<reference> Observations on RV by Japan

Figure 6
Explanation of baseline approach

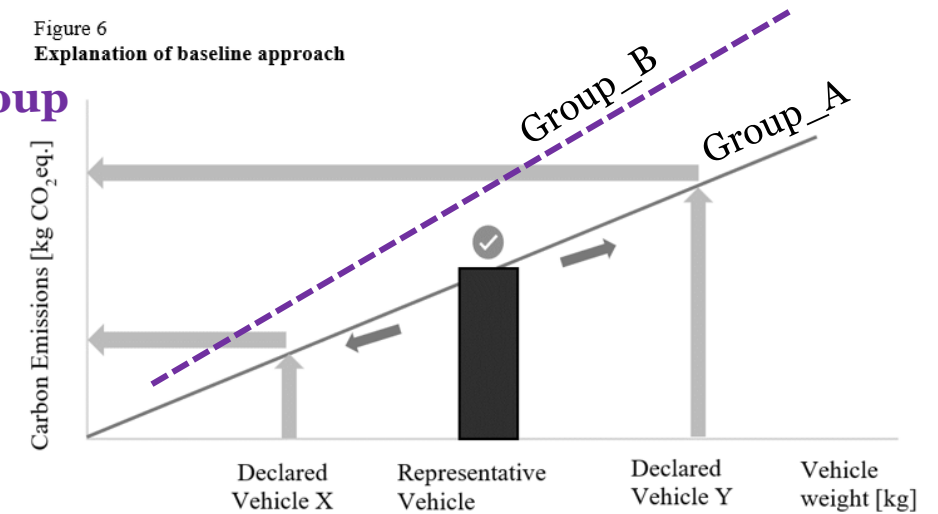
(b) Group definition based on that each group should have unique slope
: **proposed grouping doesn't justify to have unique slope per group**

so many unclear terminology and inconsistency

grouping per proportional weight of each material ?

It's quite clear that the slope will be unique since the intensity of each material might be unique

hard to understand the intention

If a traction battery is excluded,
ICE/OVC-HEV/NOVC-HEV should be same group

Collapse the concept (grouping has almost no chance)

What is a current methodology
for multiple production locations ?

Figure 6
Explanation of baseline approach

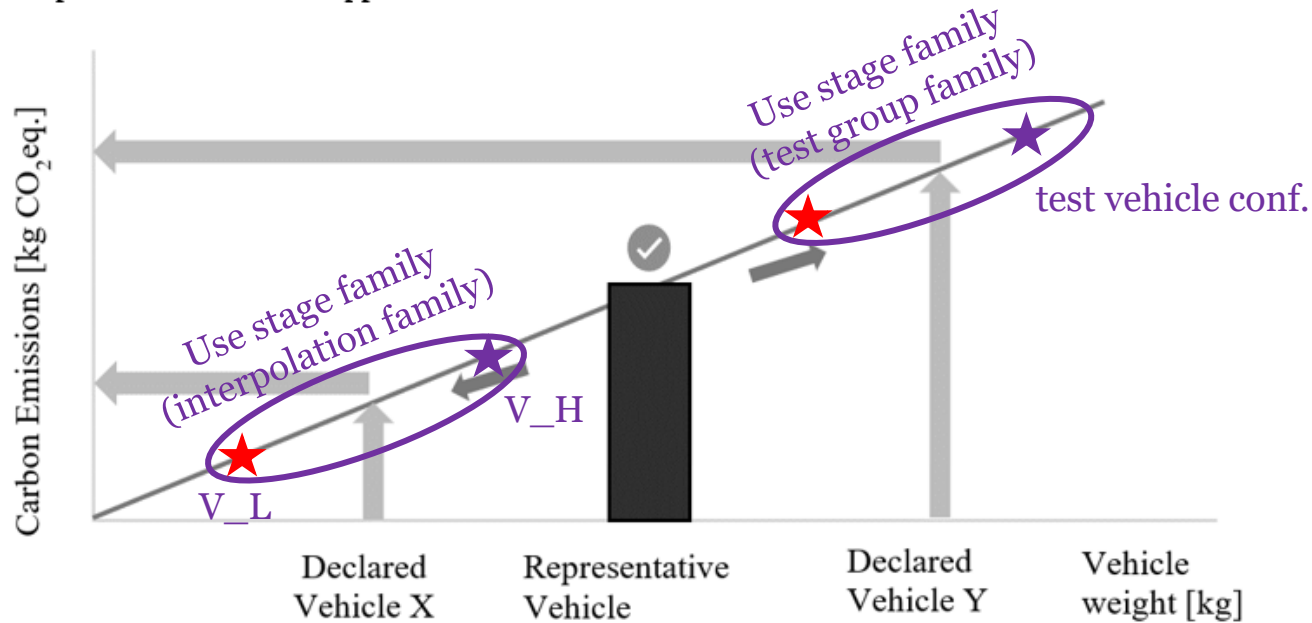
3. DV selection : can be used for “cheating”

<potential solution> allow only specific configuration (★) for DV selection

Since no clear CFP scheme exists like CO2 regulation,
best case configuration (★) will be used to represent for use stage family.
